November 2, 2006

**RE: Response to EPA Letter dated September 20, 2006
Sherwin-Williams Gibbsboro Sites, Evaluation of Strategic Sampling Results,
Vacant Lot and Associated Reaches of White Sands Branch**

| PROJECT NAME: Sherwin-Williams Gibbsboro Remedial Investigation |

| VACANT LOT PROPOSED SAMPLE LOCATION MAP | | |

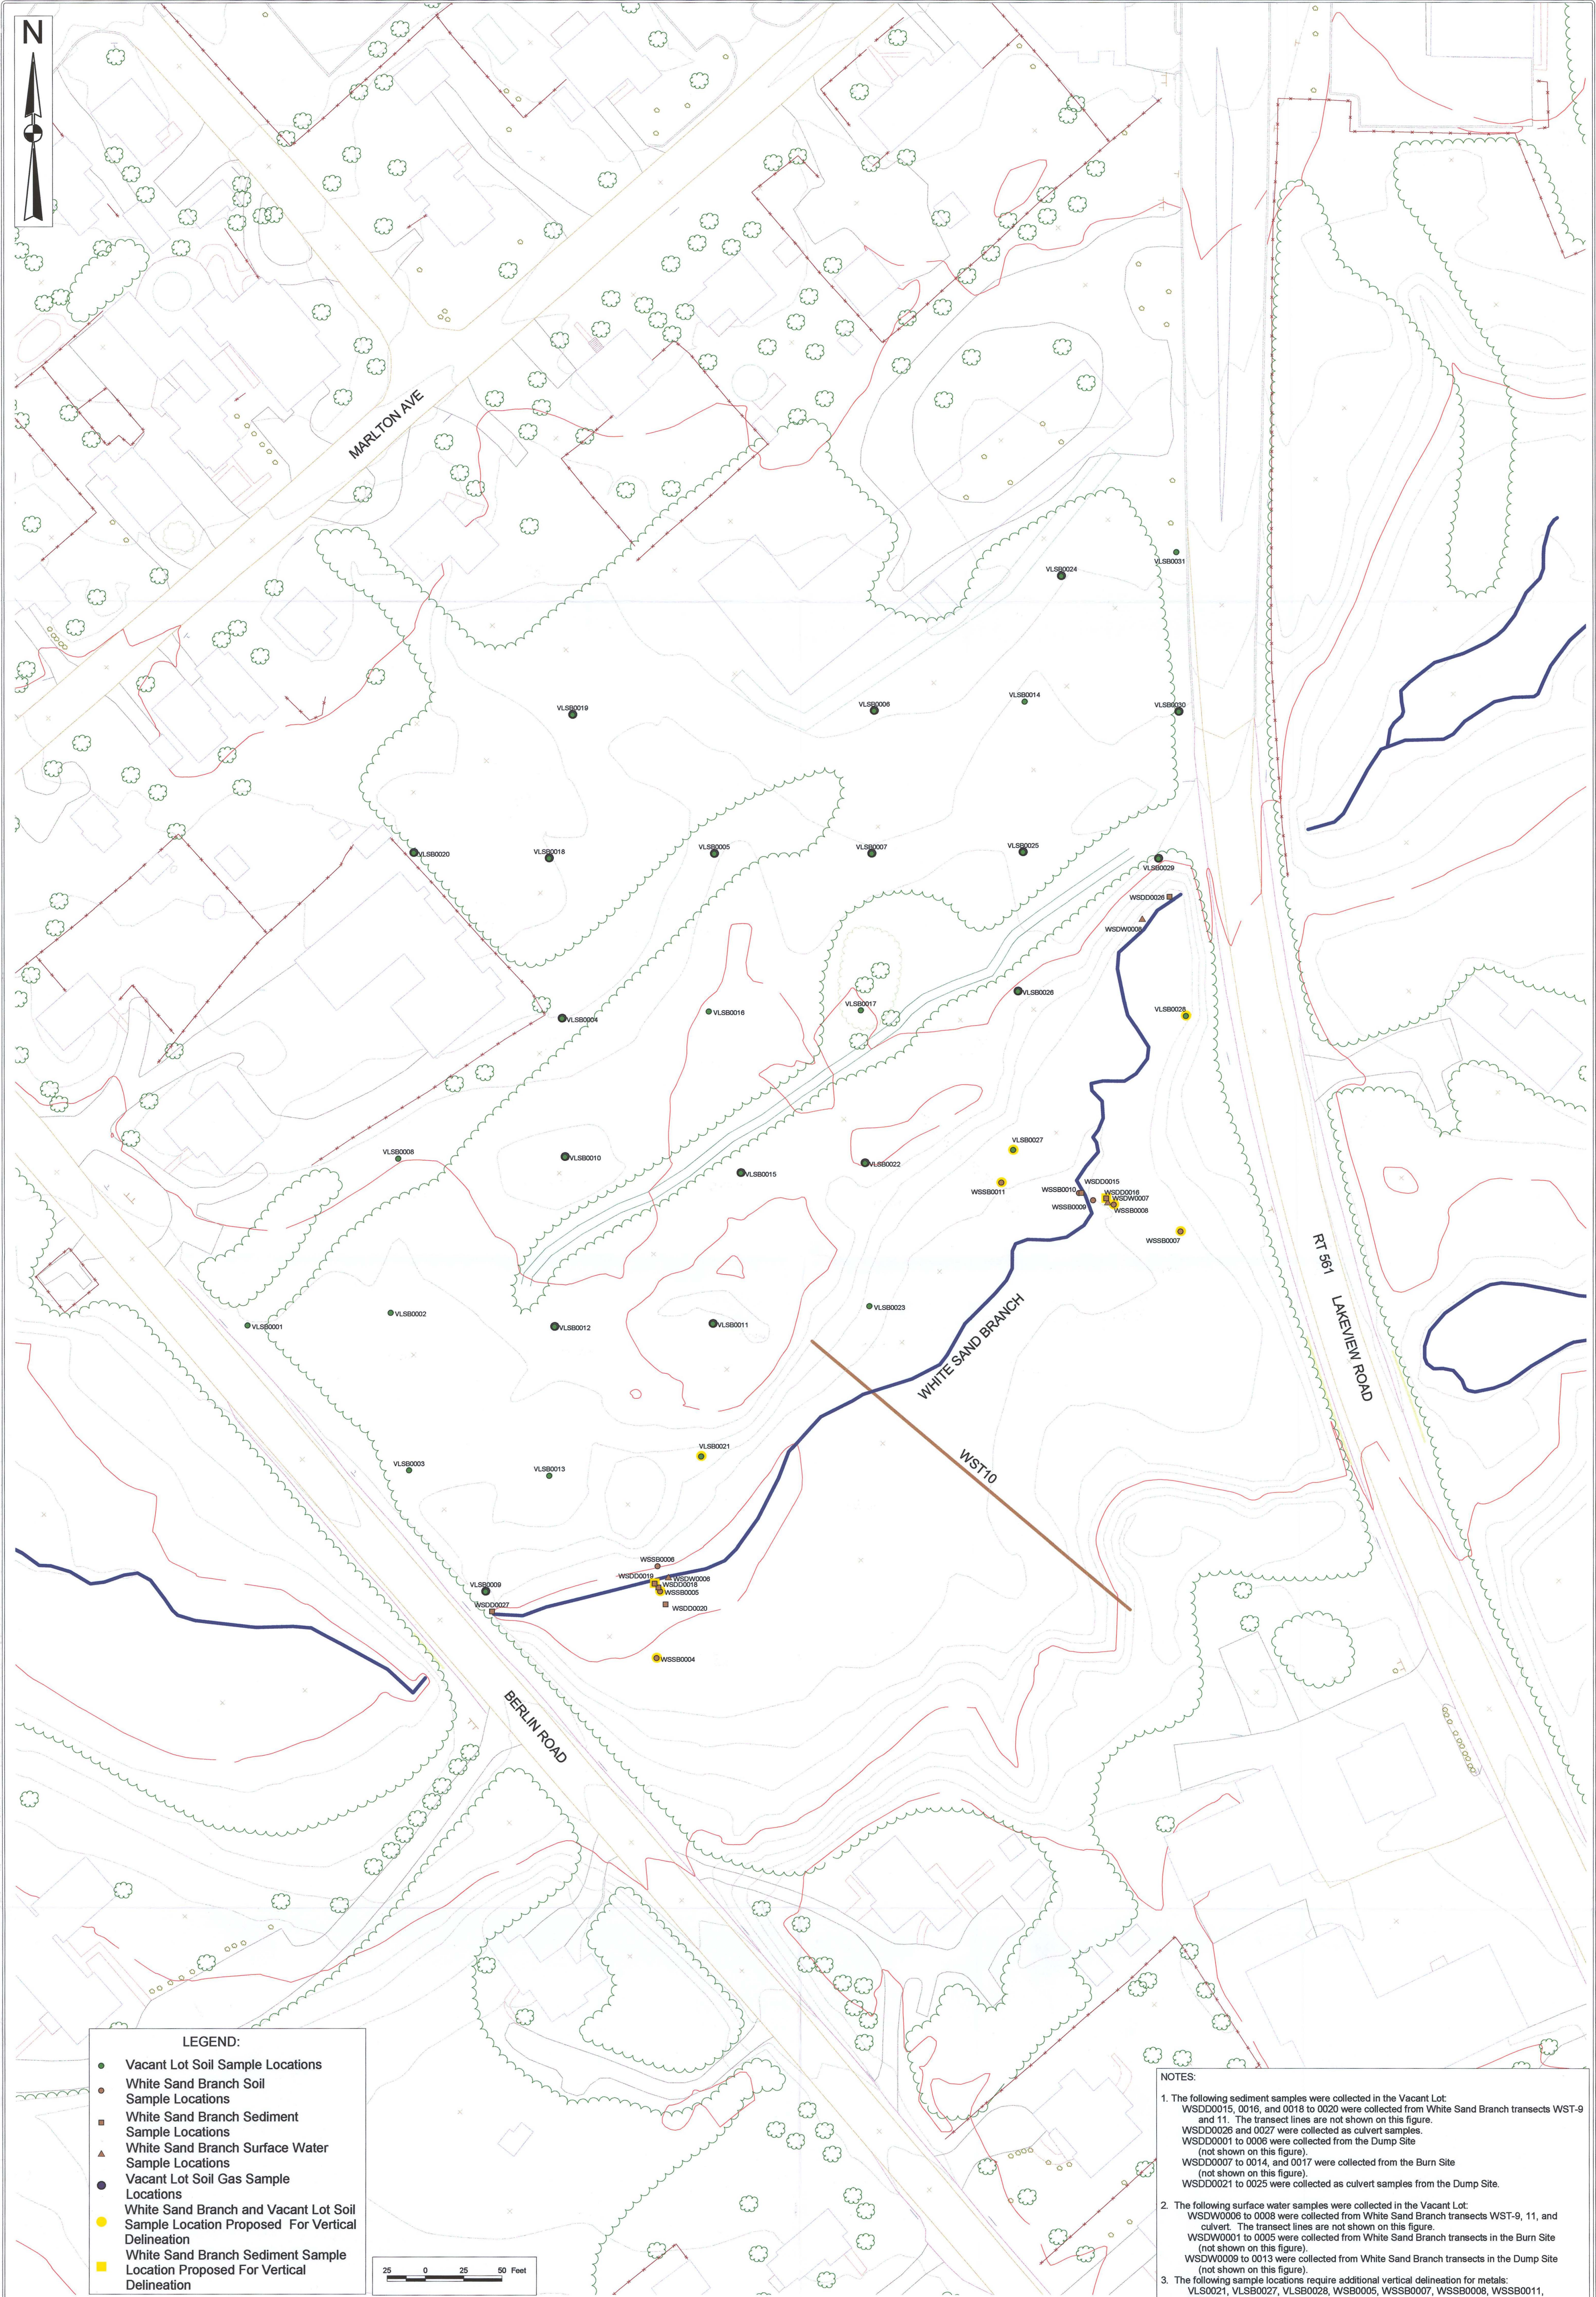
As noted above, EPA concurs with the depth intervals (2.5 – 3.0') and locations (WSDD0016 and WSDD-0019) proposed for further vertical delineation sampling along White Sands Branch within the Vacant Lot vicinity. This is based on the assumption that the XRF field screening tool will also be used to generate screening data for possible field decisions.

1. *EPA is requesting that the following Vacant Lot soil sample locations be further delineated vertically: VLSB0021, VLSB0027, and VLSB0028. VLSB0021 and VLSB0027 both had exceedances for metals and were only sampled to 0 -0.5'. VLSB0028 has been proposed due to the fact that culvert sample (sediment) WSDD0026 had exceedances for metals; however, transect (soil) samples were not collected due to the fact that it was proposed as a "culvert." Sampling VLSB0028 further vertically will provide confidence that contamination does not exist south of this location.*

2. *EPA is requesting that the following White Sands Branch soil sample locations be further delineated vertically: WSSB0004, WSSB0005, WSSB0007 and WSSB0008. WSSB0005 and WSSB0008 both had exceedances for metals at the 0-0.5'; however, samples were not collected and analyzed below this depth. Samples WSSB0004 and WSSB0007 are proposed to confirm the southern extent of contamination.*

The New Jersey Department of Environmental Protection (NJDEP) is in receipt of the above noted document and has completed its review. The only comment the NJDEP has for this document is that the soil sample data presented in the submittal is limited to surface soils. In addition to the proposed additional vertical delineation of sediment contamination, Sherwin Williams is required to complete vertical delineation of metals contaminated soil detected at sample location VLSB0021 and WSSB0011 on the north side of the White Sand Branch.

Sherwin-Williams will screen these locations in accordance with the XRF Screening Protocol, collect sediment samples at 2.5 – 3.0' and analyze them for the revised COPCs (TAL metals only) as approved by EPA. Additional vertical delineation samples will be screened and selected for laboratory analysis in accordance with the XRF Screening Protocol. The proposed sample locations are highlighted on revised Figure 5 (enclosed).

Sherwin-Williams will screen these locations in accordance with the XRF Screening Protocol, collect soil samples at 2.0 – 2.5' and analyze them for the revised COPCs (TAL metals only) as approved by EPA. Additional vertical delineation samples will be screened and selected for laboratory analysis in accordance with the XRF Screening Protocol. The proposed sample locations are highlighted on revised Figure 5 (enclosed).

Sherwin-Williams will screen these locations in accordance with the XRF Screening Protocol, collect soil samples at 2.0 – 2.5' and analyze them for the revised COPCs (TAL metals only) as approved by EPA. Additional vertical delineation samples will be screened and selected for laboratory analysis in accordance with the XRF Screening Protocol. The proposed sample locations are highlighted on revised Figure 5 (enclosed).

Sherwin-Williams will screen these locations in accordance with the XRF Screening Protocol, collect soil samples at 2.0 – 2.5' and analyze them for the revised COPCs (TAL metals only) as approved by EPA. Additional vertical delineation samples will be screened and selected for laboratory analysis in accordance with the XRF Screening Protocol. The proposed sample locations are highlighted on revised Figure 5 (enclosed).
